In Reply Refer To: HSSD/B-157

Thank you for your company's letter of March 20, 2007, requesting the Federal Highway Administration (FHWA) acceptance of modifications to the CASS-TL-4 cable barrier system and the CASS Cable Terminal. Accompanying your letter were drawings of the modified barrier and terminal. You requested that we find these devices acceptable for use on the National Highway System (NHS) under the provisions of the National Cooperative Highway Research Program (NCHRP) Report 350 "Recommended Procedures for the Safety Performance Evaluation of Highway Features."

ELEVATION 4-CABLE CASS-T1A TERMINAL

<b>4-CABLE CASS-TL4 PROPOSAL</b>		GALV SPEC:		
		SHIPPING WT:		
		DRW	E.A.S.	2/2/2007
		CHK	G.N.	2/2/2007
SHT: 1 OF 1		SIZE: B		
DWG NO.		Heights	REV	
TRINITY HIGHWAY PRODUCTS, LLC			0

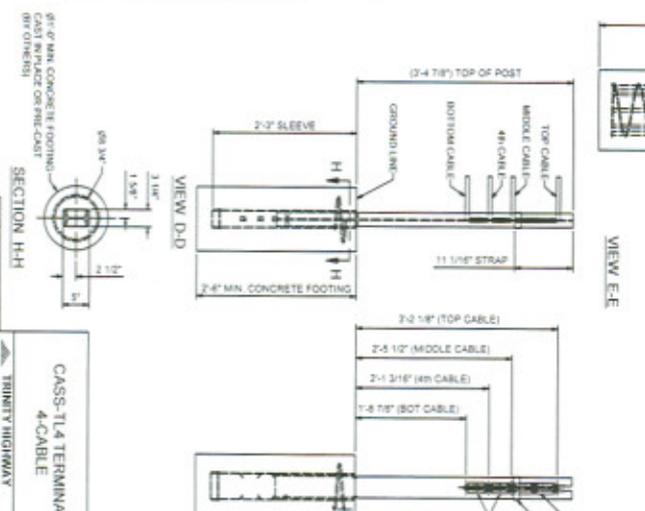
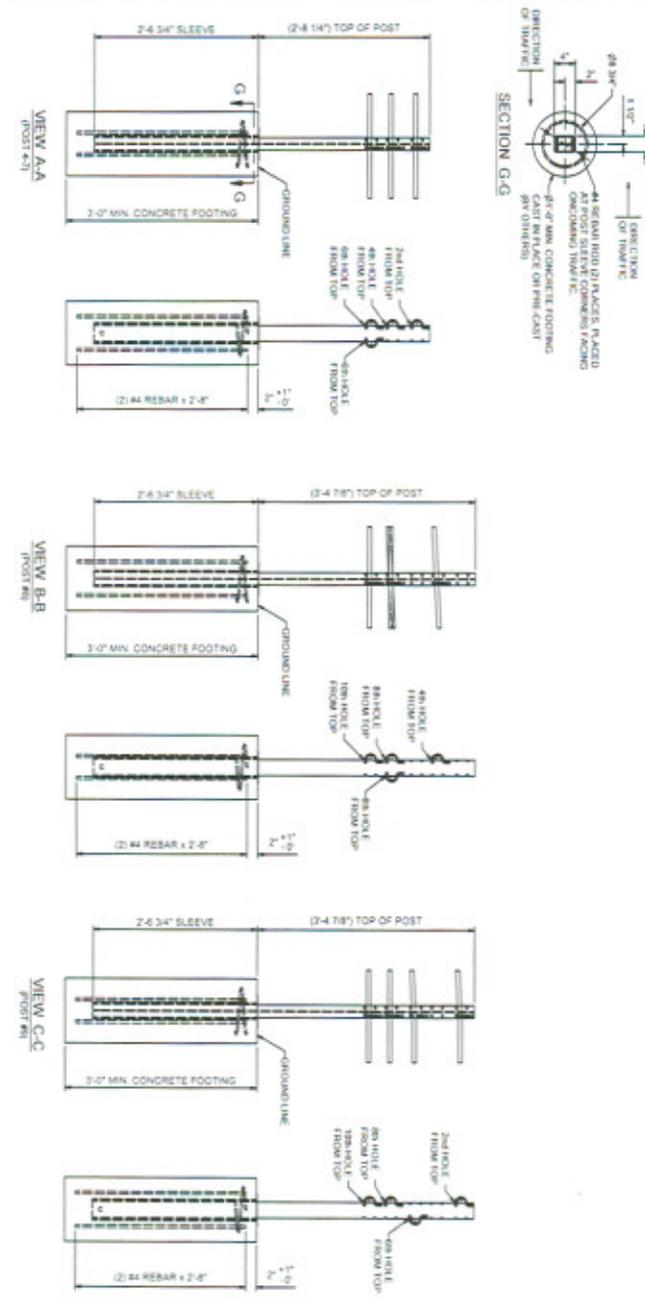
You also requested a modification to the NCHRP Report 350 TL-3 compliant terminal to accommodate the fourth cable. The modification includes increasing the length of the CASS Cable Terminal through the addition of a fourth Cable Release Post as shown in the enclosed drawing. The fourth cable remains at the 640 mm height on the traffic side of the terminal from post #9 through post #4, at which point it begins to descend towards its terminus at Cable Release Post #1X.

In spite of the above caveat, the modification to the CASS TL-4 design described above using 4 cables may be used as either a roadside or median barrier on the NHS when such use is acceptable to the contracting agency. Although the cables used in the test were not pre-stretched, this acceptance is also valid if and when pre-stretched cables are used, assuming that the recommended post-tensioning is applied to the cables. The modified CASS-TL-4 end terminal is likewise found to be acceptable.

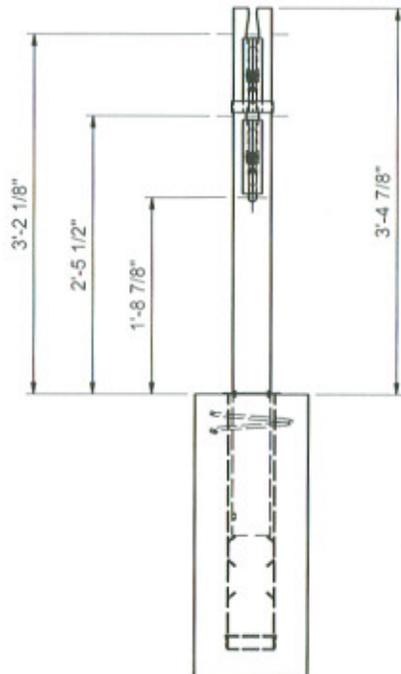
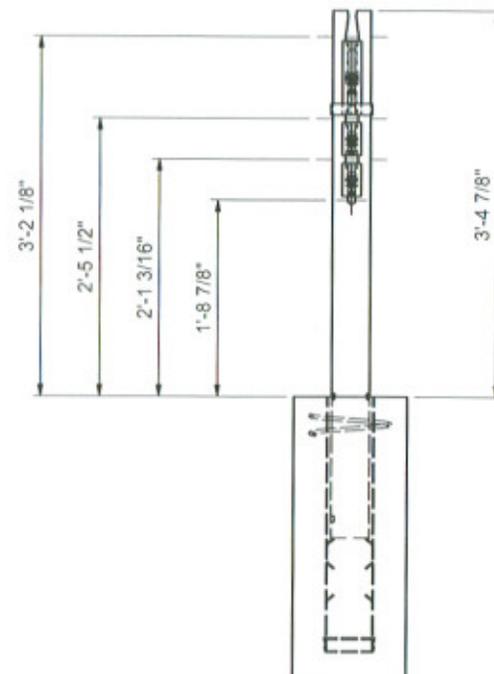
In the FHWA acceptance letter B-141 dated November 17, 2005, the FHWA accepted the 3-cable CASS-TL-4 Cable Safety System to test level 4 (TL-4) criteria. Your current request is to modify that barrier and terminal design to incorporate a fourth cable at a height of 640 mm (25-3/16 inch), midway between the bottom and middle cables of the original TL-4 CASS.

Because the addition of the fourth cable and associated terminal hardware is not considered to be detrimental to the performance of the crash tested system, and is indeed likely to increase the capacity and improve the performance, the CASS-TL-4 devices described in the requests above and detailed in the enclosed drawings are acceptable for use on the NHS under the range of conditions tested, when proposed by a State.
